**SUBJECT: Scenic Waterway Interference & General/Local Surface Water
Evaluation for Deschutes Ground Water Study Area**

PUBLIC INTEREST REVIEW FOR GROUND WATER APPLICATIONS

TO: Water Rights Section Date 5/23/2013
 FROM: Ground Water/Hydrology Section K. Lite
Reviewer's Name
 SUBJECT: Application G- 17617 Supersedes review of
Date of Review(s)

A. GENERAL INFORMATION: Applicant's Name: Hoffman County: Deschutes

G-17617: Tumalo and Bend Quadrangles

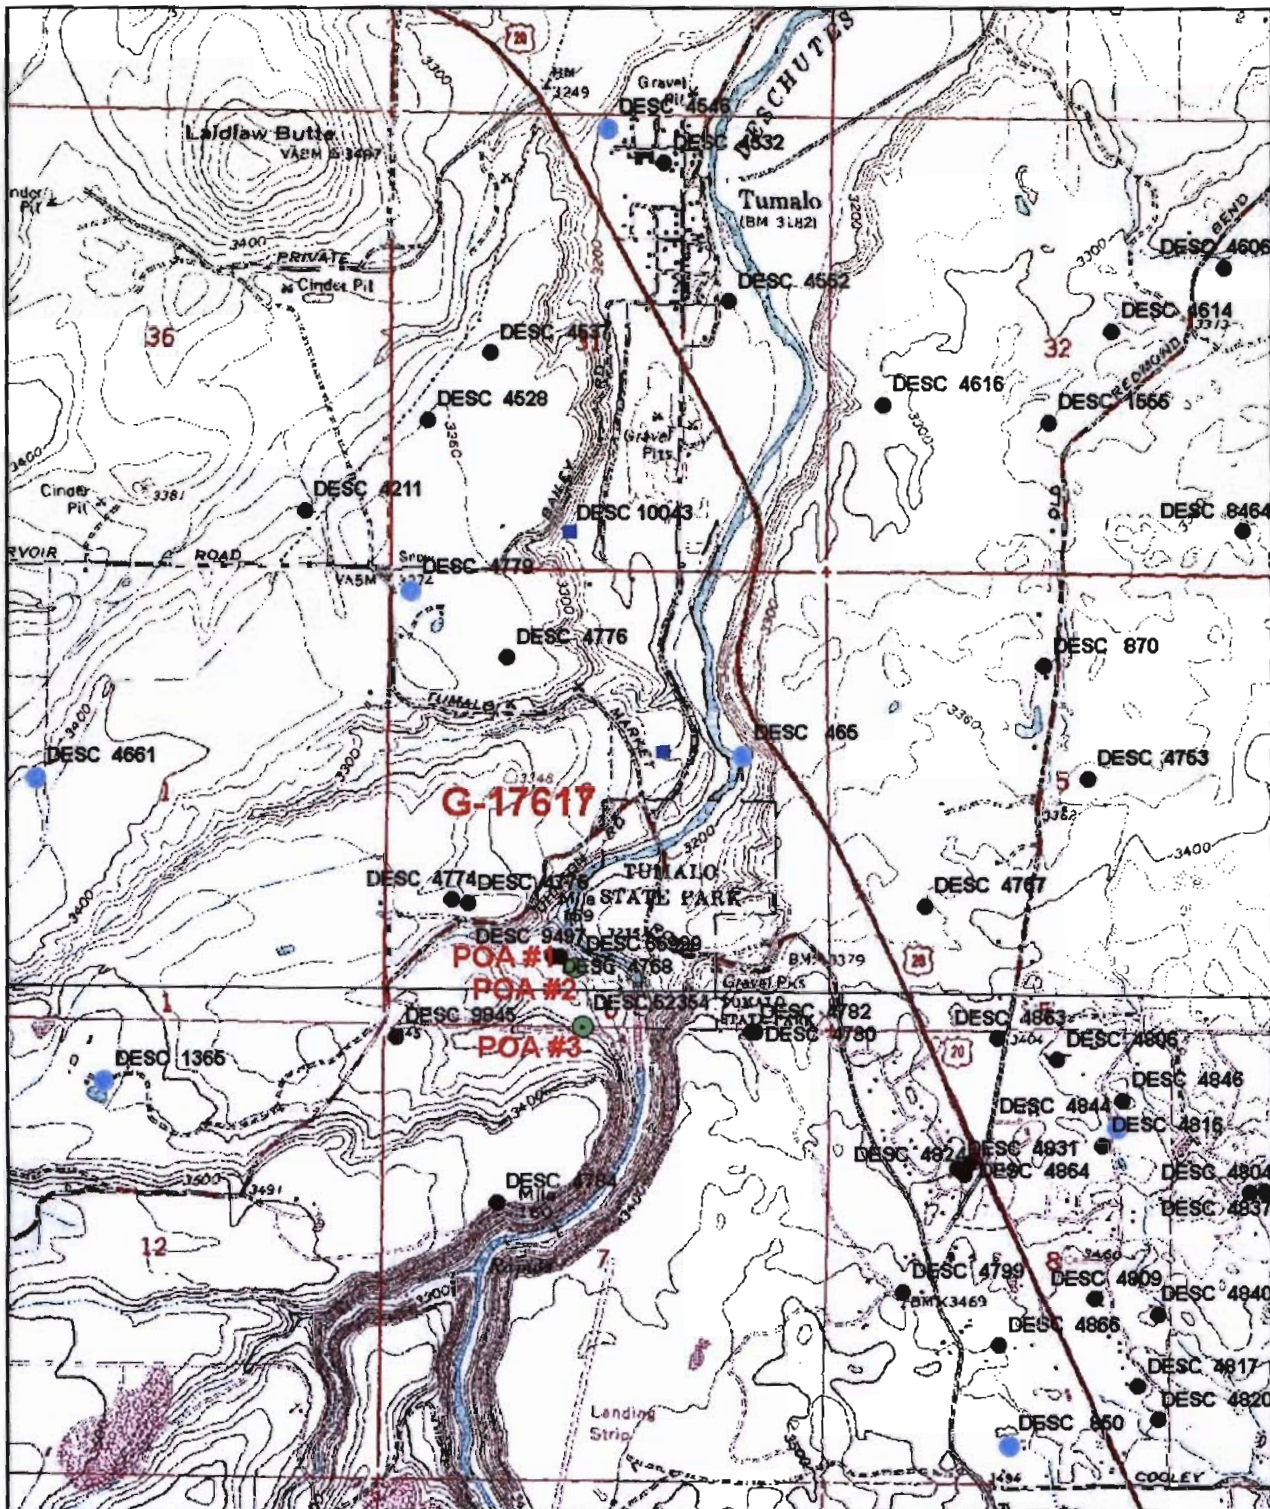
A4. **Comments:** WELL #1 IS CONSTRUCTED INTO WATER BEARING ZONES WITHIN PLEISTOCENE AGE ASHFLOW DEPOSITS AND INTERBEDDED ALLUVIUM OVERLYING THE DESCHUTES FM. WELLS 2 AND 3 ARE CONSTRUCTED INTO DESCHUTES FM. GROUND WATER FLOW IS TOWARDS THE NORTH WITH THE NEAREST DISCHARGE AREA (DESCHUTES RIVER) ABOUT 3-4 MILES DISTANCE (WELL #1) AND APPROXIMATELY 15 MILES (WELLS 2 & 3) TO THE DESCHUTES RIVER. WATER LEVELS IN THE WELLS ARE BELOW THE ELEVATION OF THE NEAREST SURFACE WATER SOURCE (ALSO DESCHUTES RIVER). WELLS ARE LOCATED WITHIN THE DESCHUTES GROUND WATER STUDY AREA AND SUBJECT TO DIVISION 690-505-0500 TO 0620.
